Cyprus Plateau Mining Corporation
P.O. Drawer PMC
Price, Utah 84501
(801) 637-2875

ACT/007/006 # 2
Copy from
93A

Re: Application For Permit Change - Incidental Boundary Change -
Lease UTU-64263

**MAP 112.500 b
COAL OWNERSHIP**

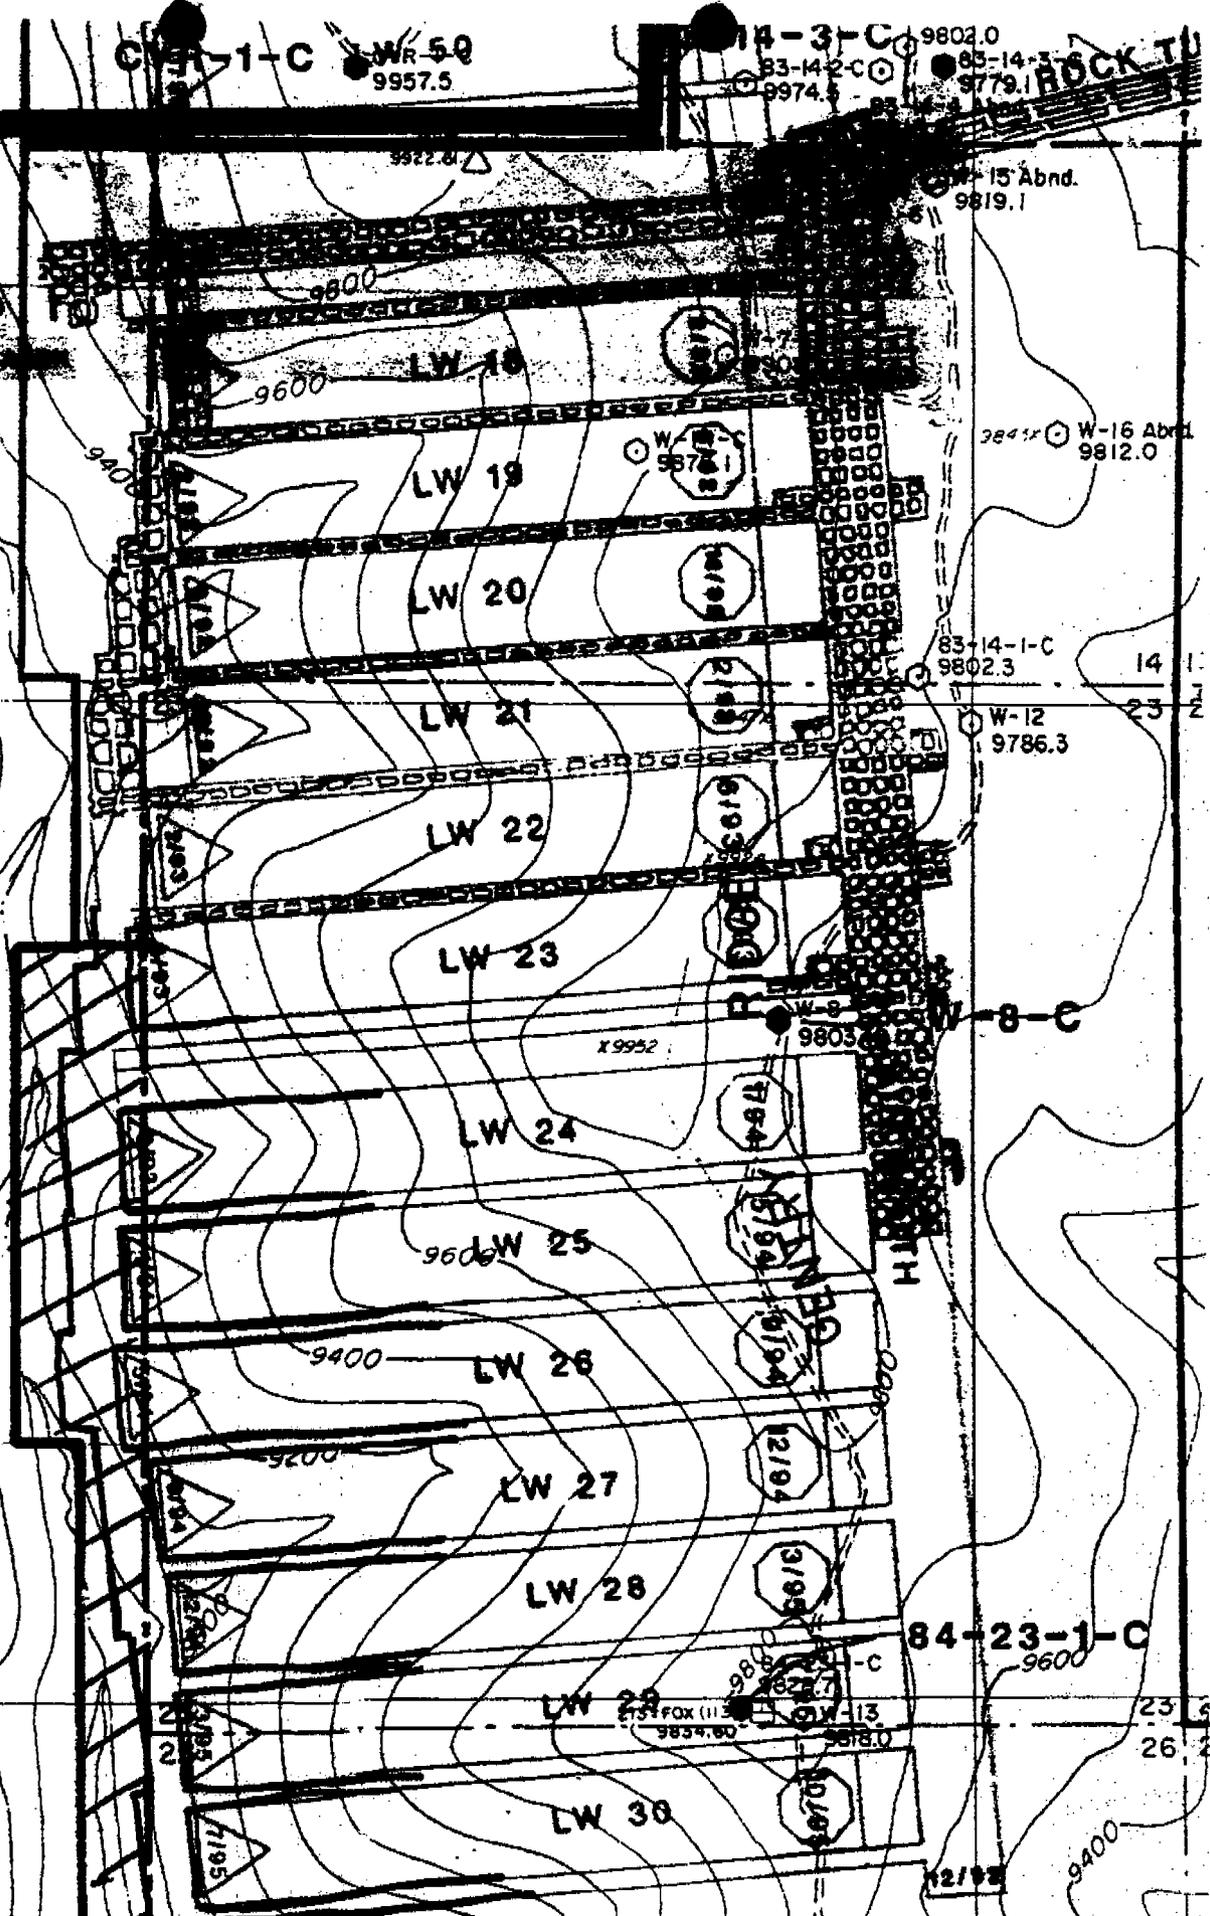
Cyprus Plateau Mining Corporation would like to ask for an Incidental Boundary Change to add 60 acres on the west side of Federal Coal Lease U-13097 as shown on Map 112.500b, Coal Ownership Map attached. This lease modification will be to Federal Coal Lease UTU-64263 and is being processed by the BLM with review by the Manti-La Sal National Forest Service. This letter and attached documentation serve as the application for permit change.

Map 116.100c, Mine Plan Wattis Seam, from our MRP has been revised to show the IBC area and the proposed mining layout and timing. Maps 112.500a, Surface Ownership and 112.500b, Coal Ownership have also been revised to show the Incidental Boundary Change area, and addition to Lease UTU-64263.

MAP 116.100C
MINE PLAN WATTIS SEAM
83-26-1 Abnd.
9776.7

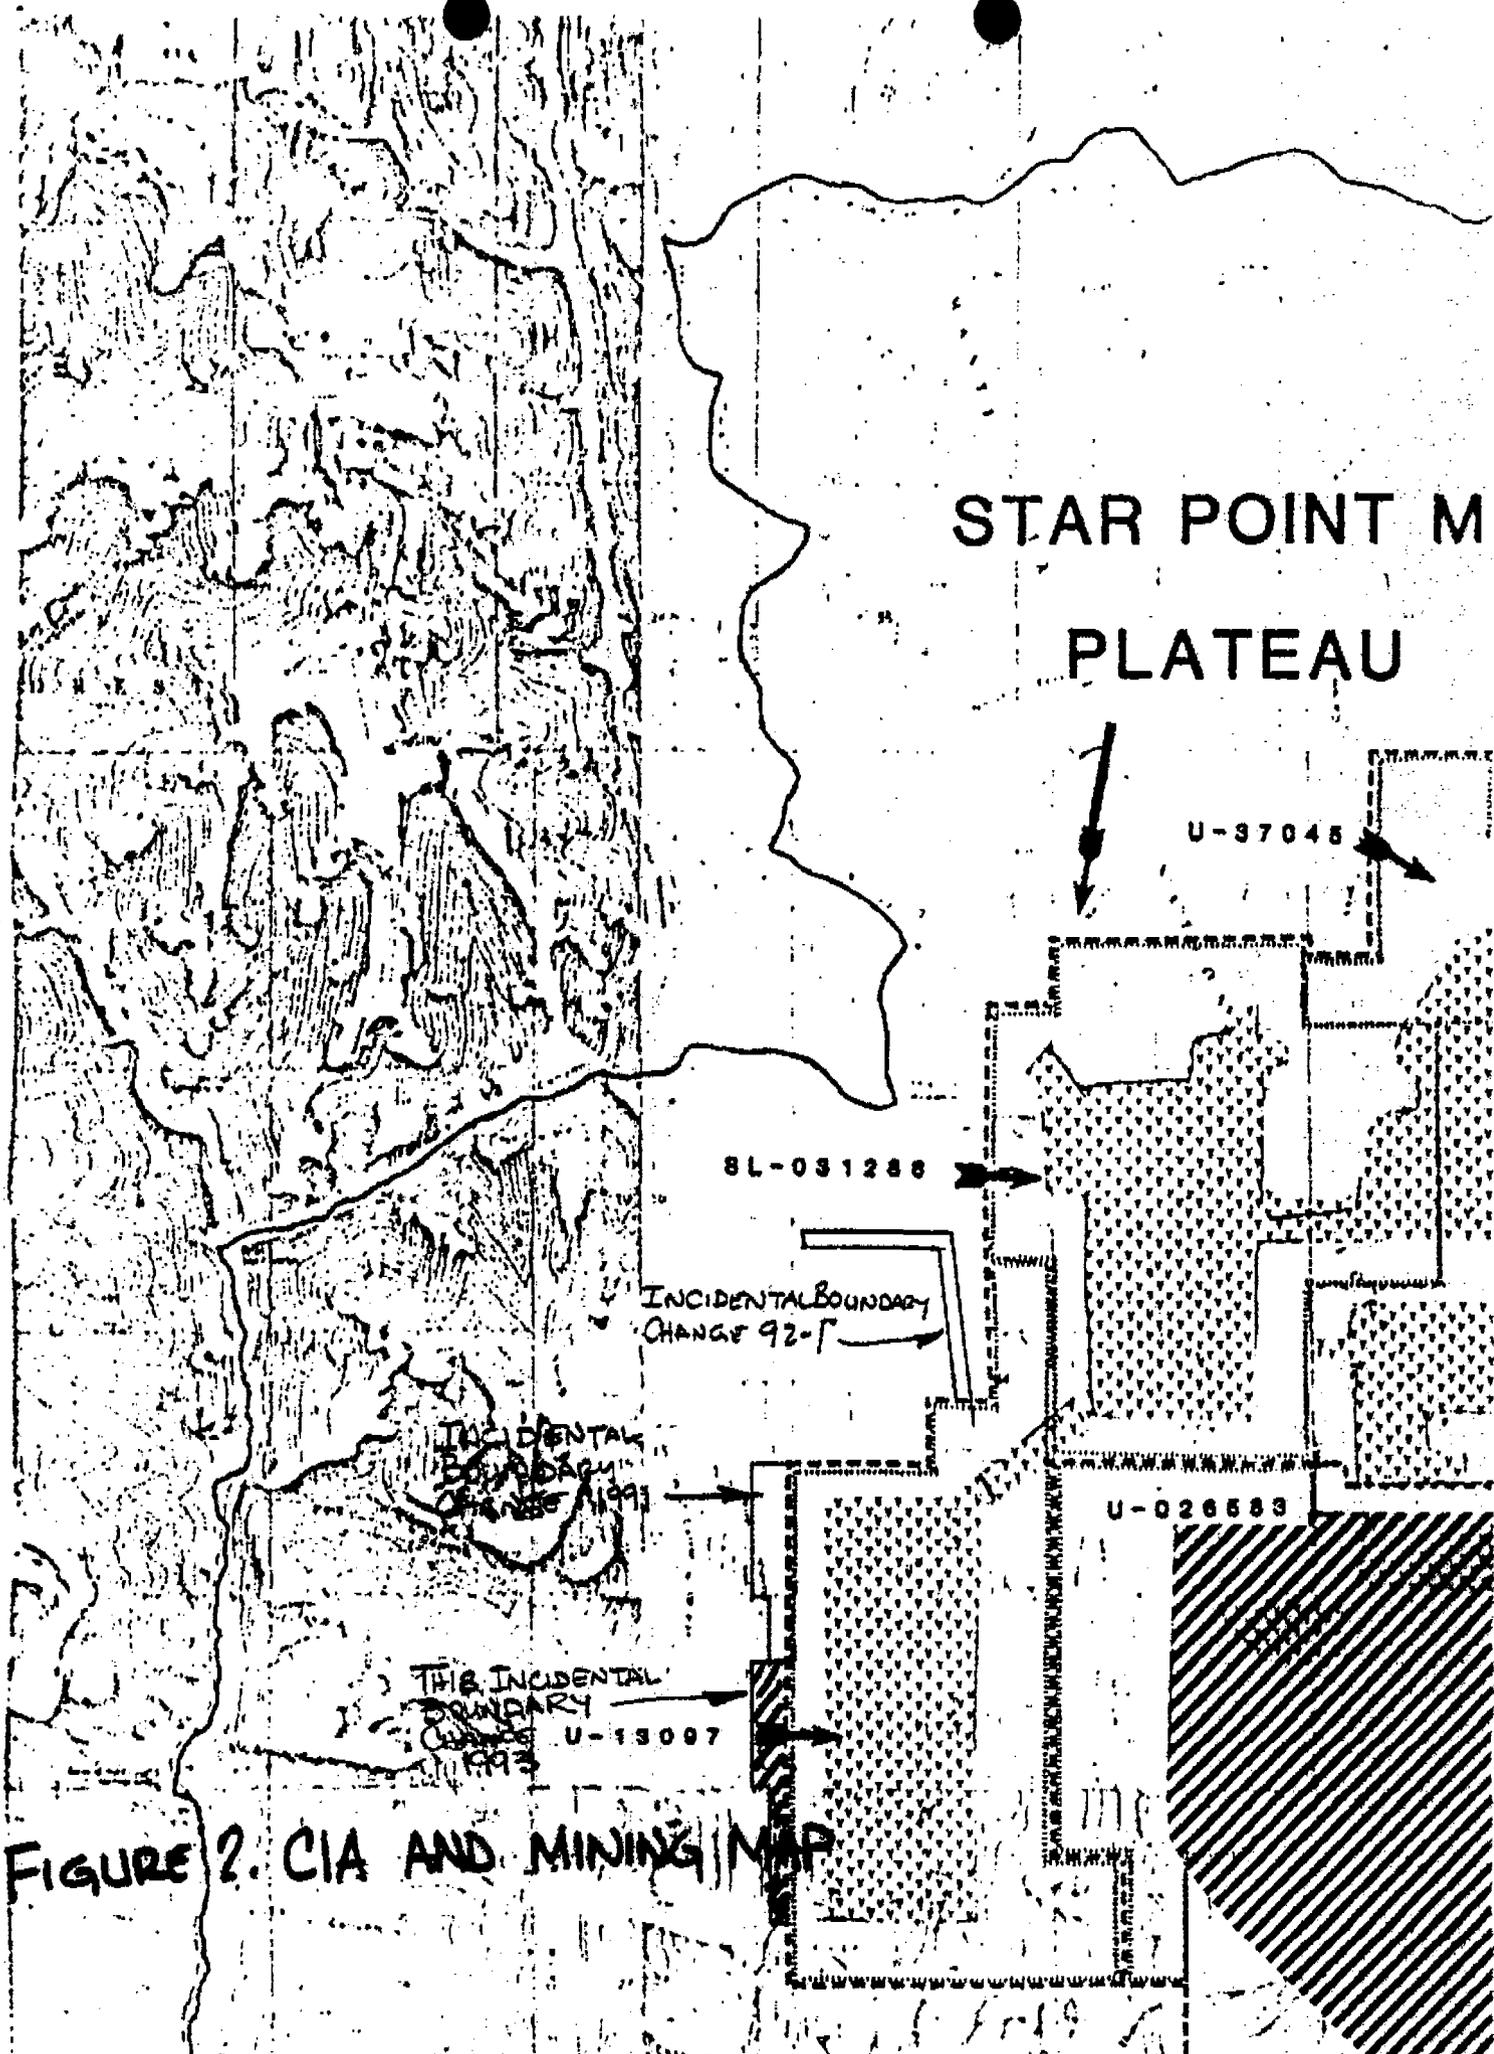
The mine layout has been made considering the Wild Cattle Hollow stream; an angle of draw of 22 degrees was used to position the mine workings to avoid subsidence damage to the stream.

FIGURE 2. CIA AND MINING MAP

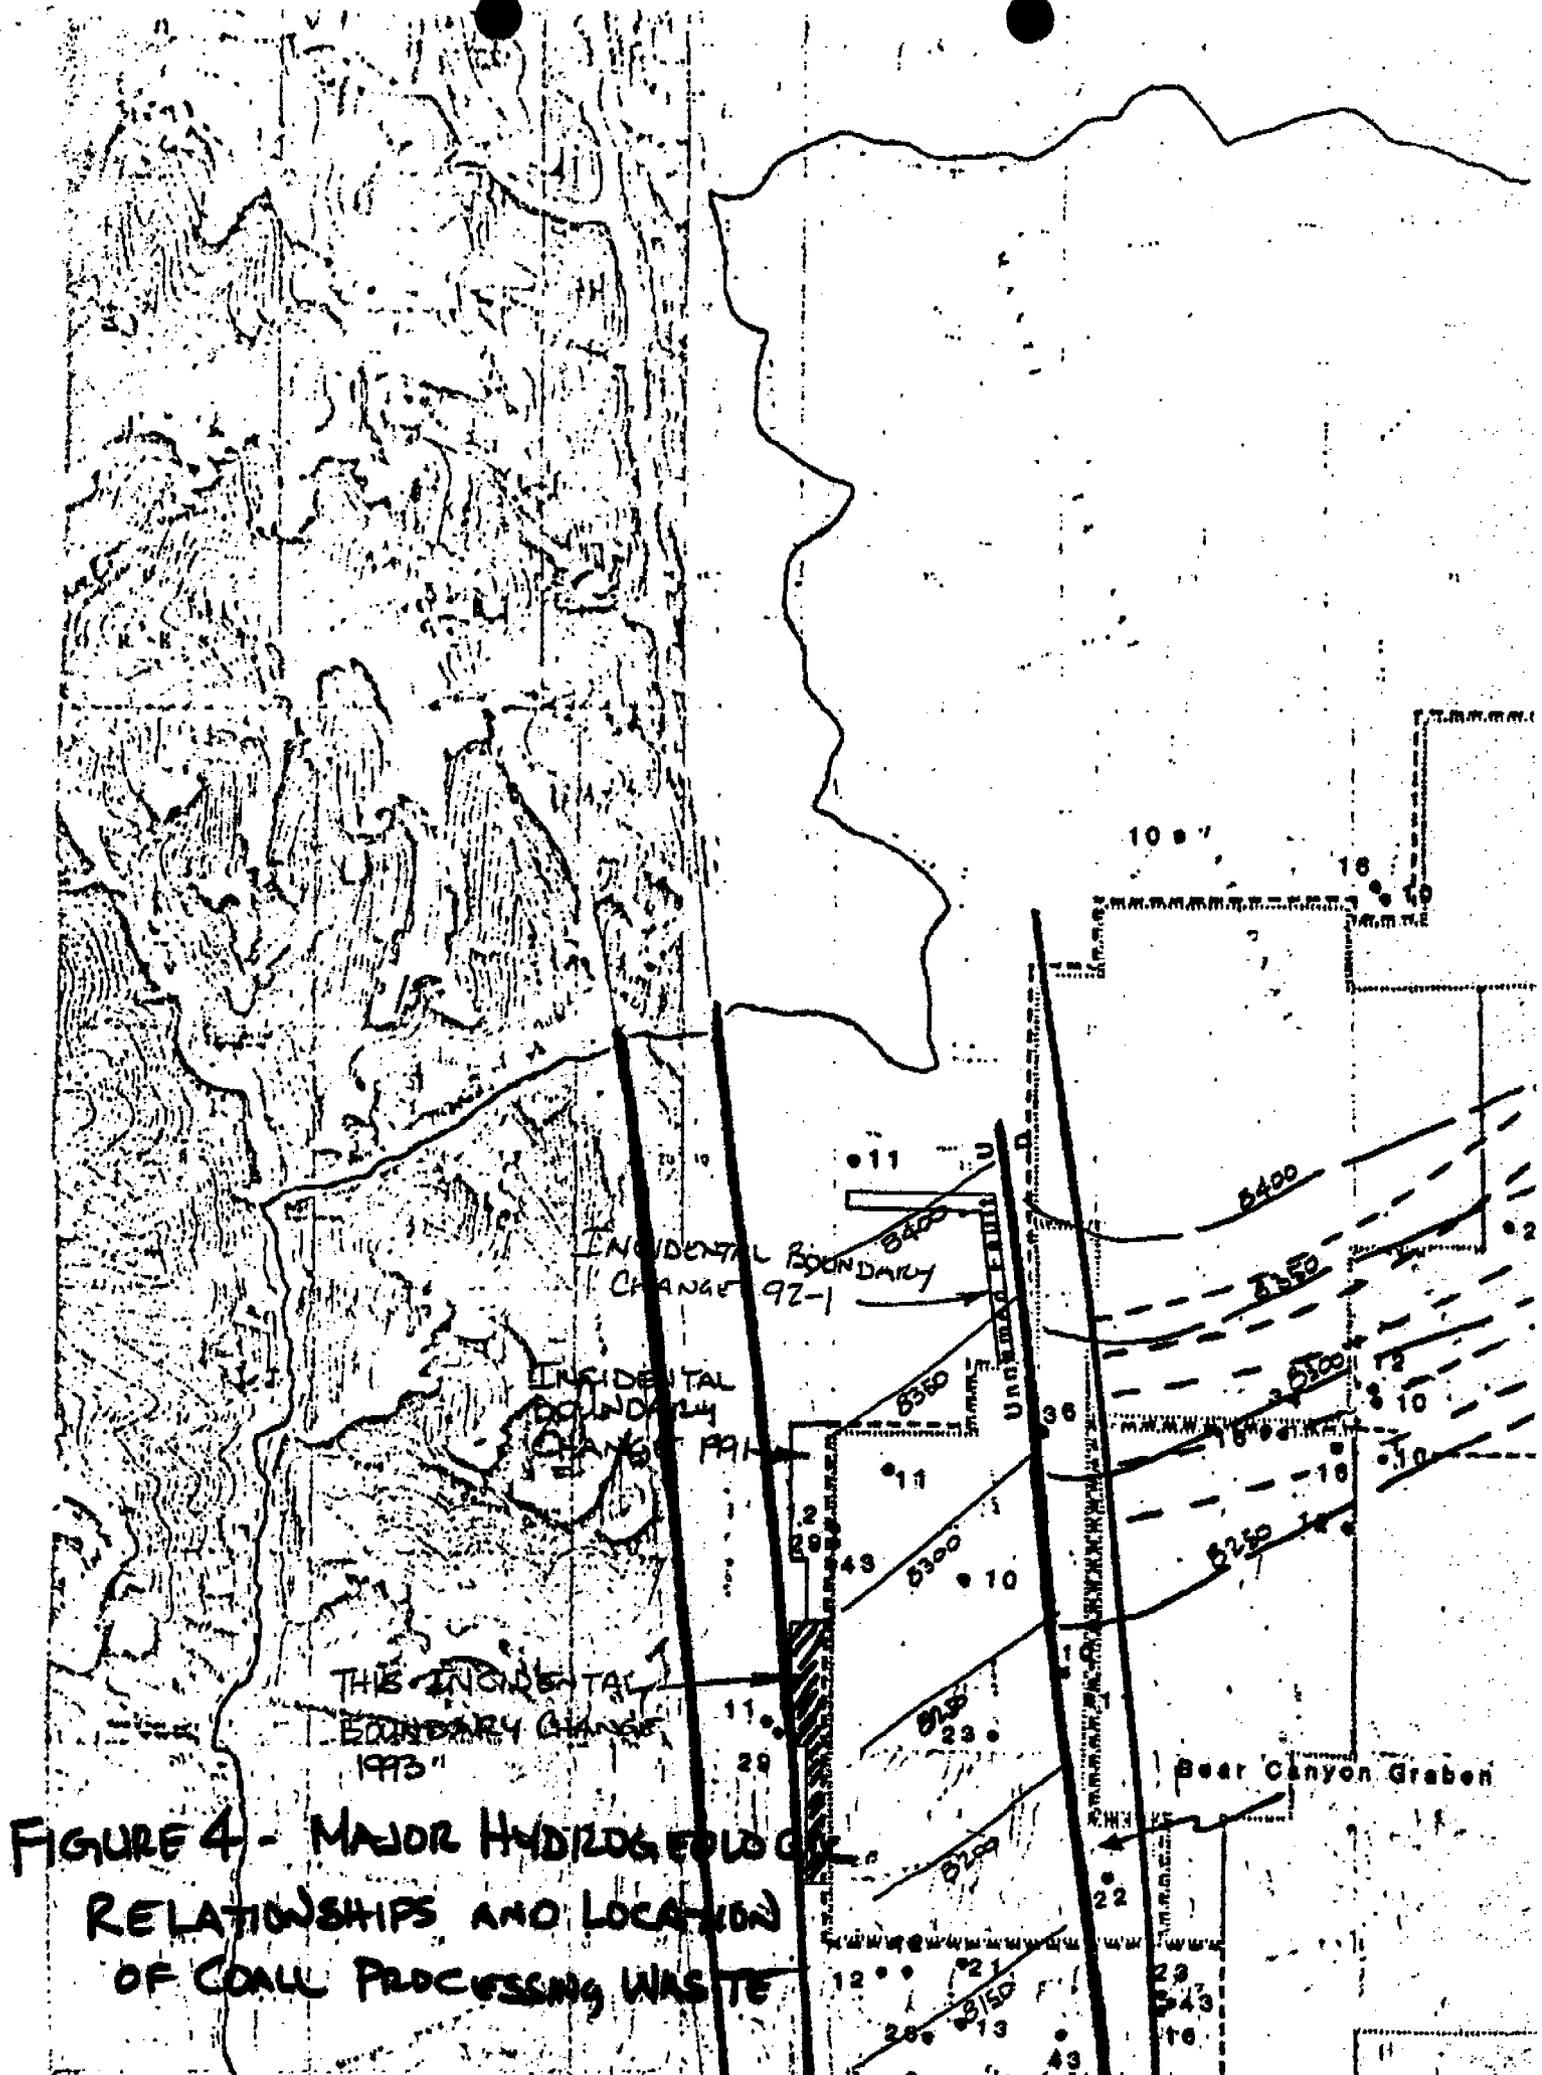
Figure 2 from the 1987 CHIA has been copied and the proposed IBC has been plotted in relationship to the CHIA boundary. As can be seen, the IBC is well within the CHIA boundary.
